**Proposed Private Plan Change – Campana Road
Clause 23 Request for Further Information Response (Transport)**

**Proposed Private Plan Change – Campana Road
Additional Clause 23 Request for Further Information Response (Transport)**

**Proposed Private Plan Change – Campana Road
Clause 23 Request for Further Information Response (Transport)**

**Proposed Private Plan Change – Campana Road
Clause 23 Request for Further Information Response (Transport)**

ATTACHMENT B – Campana Road Structure Plan (Rev. A)

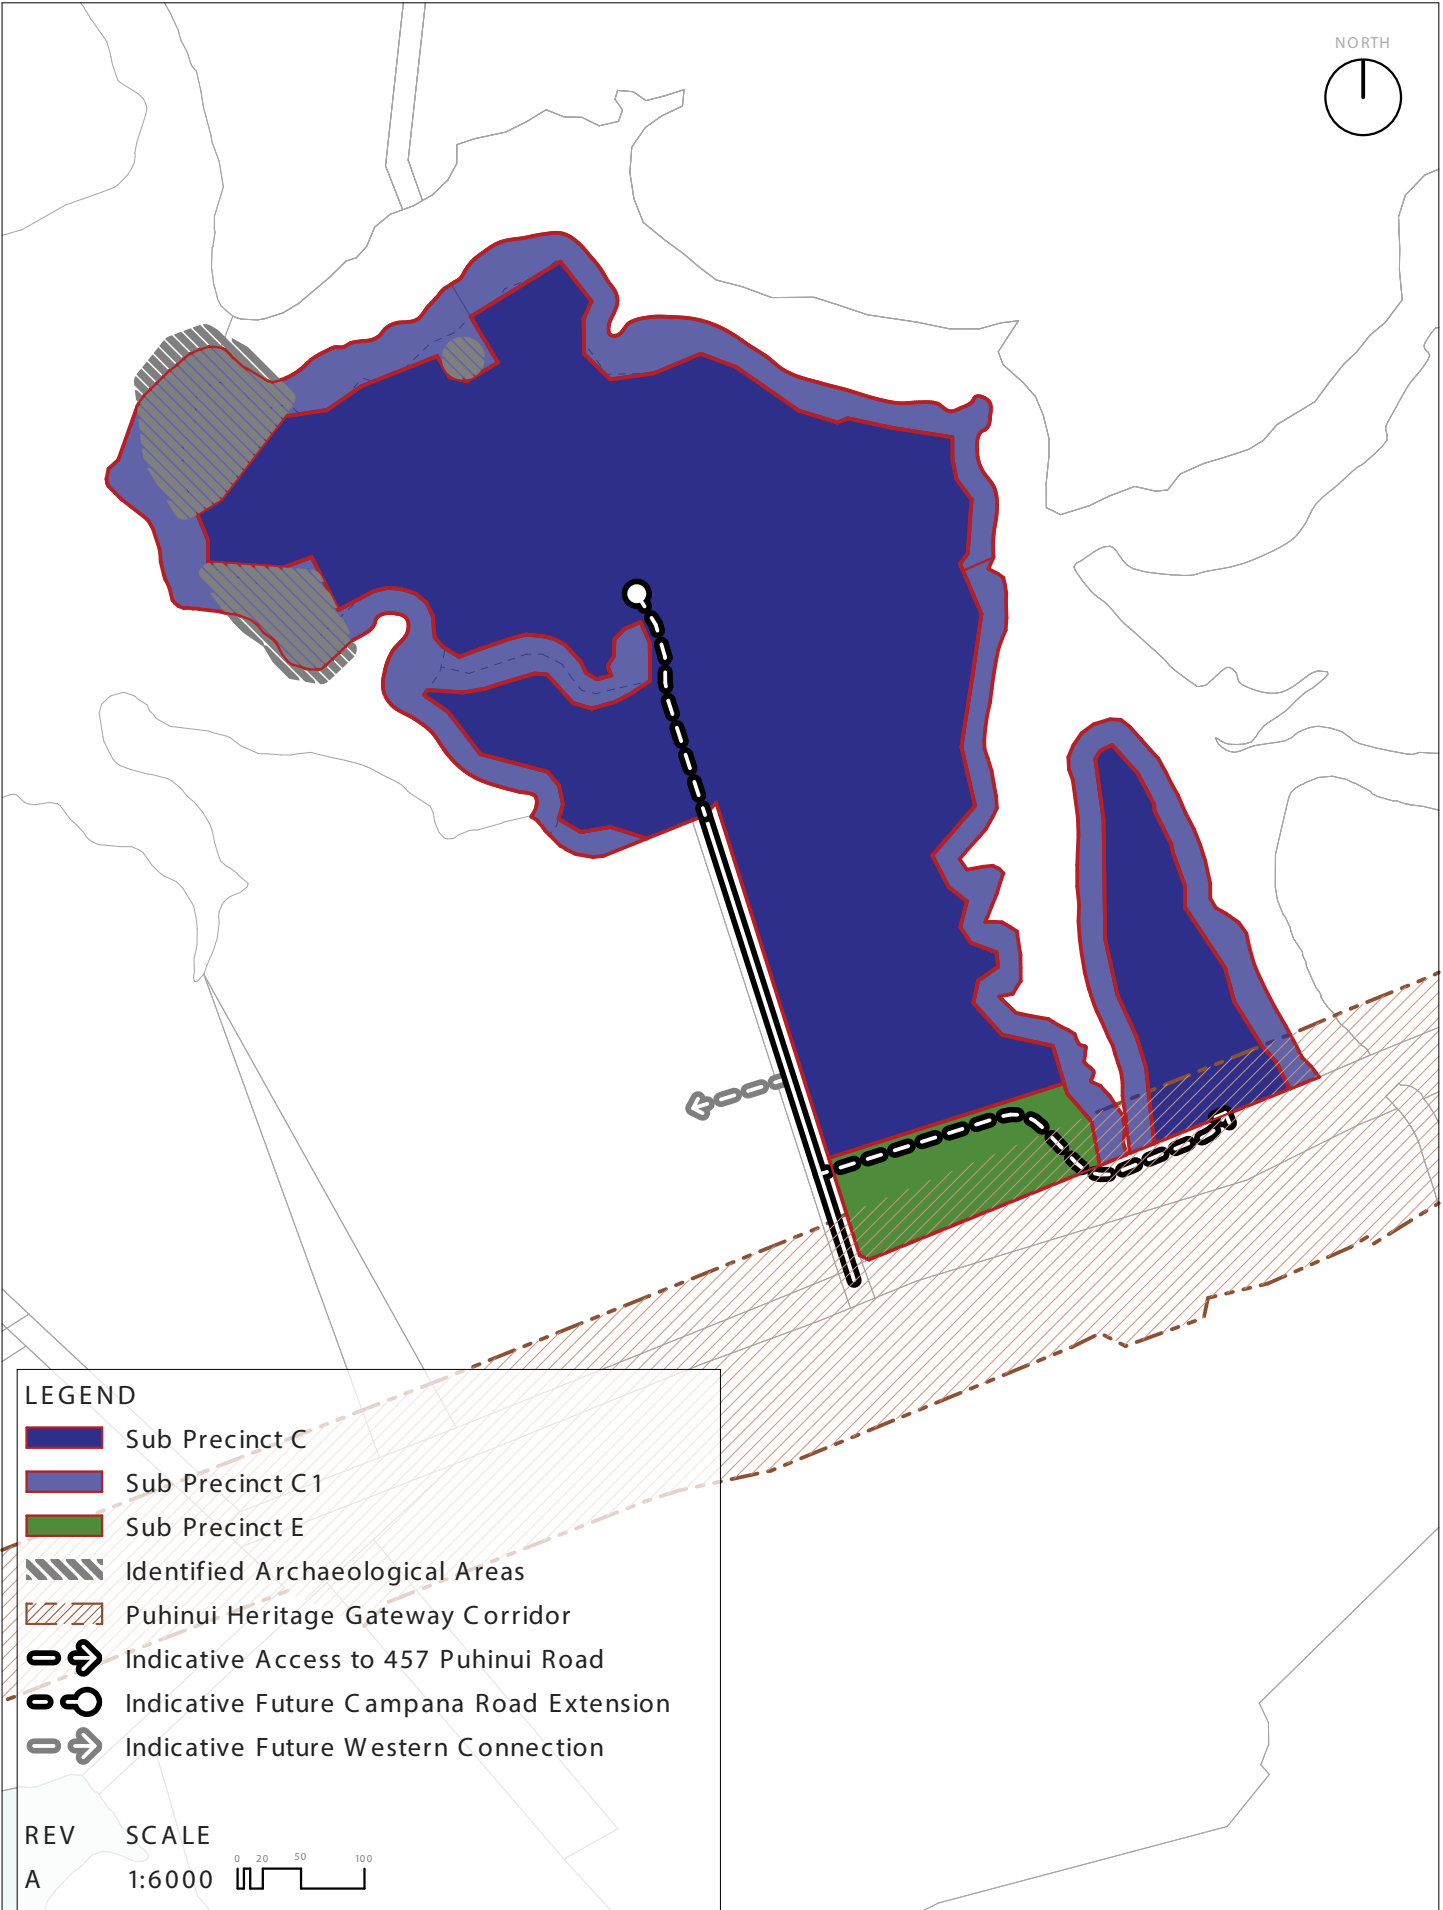
- ***A plan showing strategic transport movements, which could be an elaboration of the information presented in the plan on page 4 of the Structure Plan, showing strategic transport connections between the PPC site and the wider network and indicative internal connections within the PPC sub-precinct areas, for vehicular traffic, active modes and public transport.***

- ***Further assessment and clarification in relation to the indicated realigned access to 457 Puhinui Road, shown on the same plan.***
- ***Further assessment and clarification in relation to the indicated 'Public Walkway opportunity' following the coastlines of the peninsulas making up the PPC area. While the identified routes appear to offer significant amenity value, it would be helpful to understand how these walkways would be expected to serve the PPC site at a functional level and integrate with other provisions for access by active mode users.***

An updated Structure Plan has been prepared by other members of the Applicant's advisory teams and is attached to this response as **Attachment B**. From a transportation point of view and in response to the initial two bullet points of the Council's request above, the updated Structure Plan shows:

- The indicative extension of the Campana Road alignment to the north towards and connecting with each of the land parcels in the northern sector of the Structure Plan area;
- An indicative alignment of the accessway serving the 457 Puhinui Road property and its indicative connection to Campana Road (via the SPCA land) located a minimum of 30m north of the Puhinui Road intersection;
- A potential indicative connection (Future Western Connection) from the western side of Campana Road (and north of the accessway to 457 Puhinui Road) towards non-Plan Change land on this western side of Campana Road.

Beyond this more strategic-level and structural transport indication shown in the attached updated Structure Plan, any more detailed or specific accessway, driveway or vehicle access development is considered premature and of limited relevance to the overall consideration of the transportation implications of the Private Plan Change. Due to the nature of the current landholdings within the Plan Change area there could be any number of arrangements of future development potentially including a single comprehensive operational development requiring only a single point of entry, or alternatively several development parcels potentially subdivided from the current land-holdings or amalgamating current parcels. On this basis, any more detailed or fine-grained indication of access provision would be theoretical at best.

Figure 3: General Arrangements Plan – NOR 4B Airport to Botany
(Source: Application Material NoR 4(b) – Volume 1)

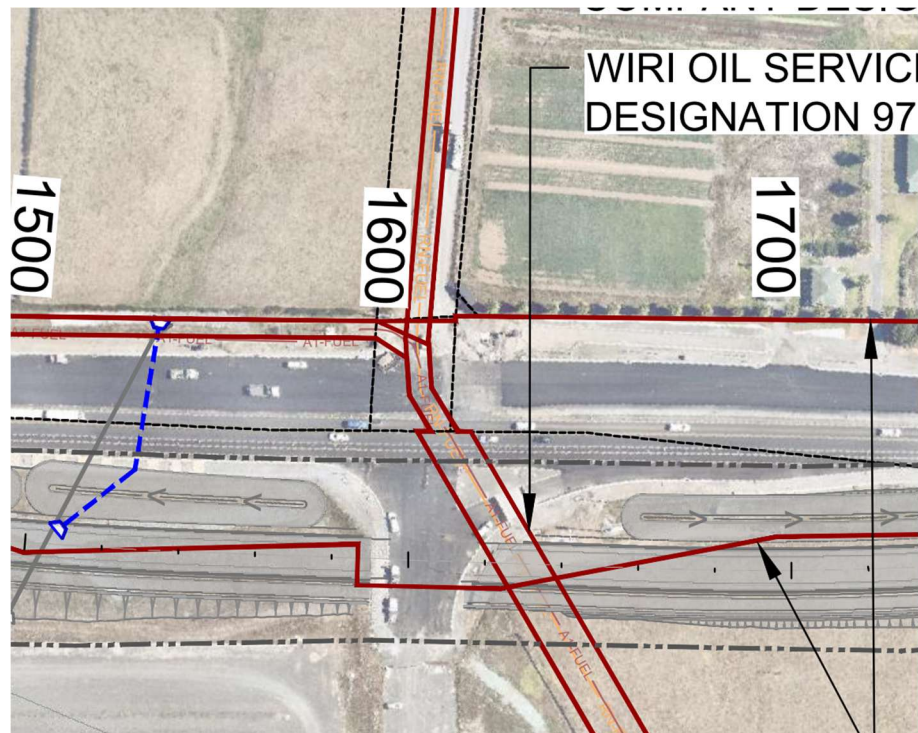
“Layout plans to confirm the 4 potential upgrade options for the Campana Road / Puhinui Road intersection, discussed in the second Clause 23 Response, and any further appropriate improvement options to ensure that the combined intersection arrangement operates at an acceptable level of service.”

The below extract from the latest Google Earth and Auckland Council GeoMaps systems respectively show the updated intersection layout of the Puhinui / Campana / Park ‘n Ride junction, and the legal boundary details of the Campana Road Nd Puhinui Road road reserve.

The above figure indicates that the legal road reserve within Campana Road (north of Puhinui Road) is 20m and the current carriageway within the legal width represents approximately 40% (or some 6m out of the 20m reserve width). It is understood that the Airport’s PnR project and upgrading of the intersection to traffic signals (see below) has not altered the property or road reserve boundaries of Campana Road.

Figure 2 above indicates that the upgrading of the Campana intersection alongside the Airport's Park n Ride South (PnR) development has delivered the intersection upgrading including substantial widening on the southern side of Puhinui Road. From the latest references available, for example through the Airport to Botany Notice of Requirement (see Figure 3 below), it is understood that NZTA will ultimately incorporate the widened intersection within the legal boundaries (and State Highway designation) applying to Puhinui Road.

On the basis of the above references, it can be confirmed that there is sufficient legal width within the Campana Road corridor (up to 14m additional to current carriageway) to facilitate the addition of an extra through or turning lane (or both) should this be required at a later stage of development of the Plan Change land and activities.
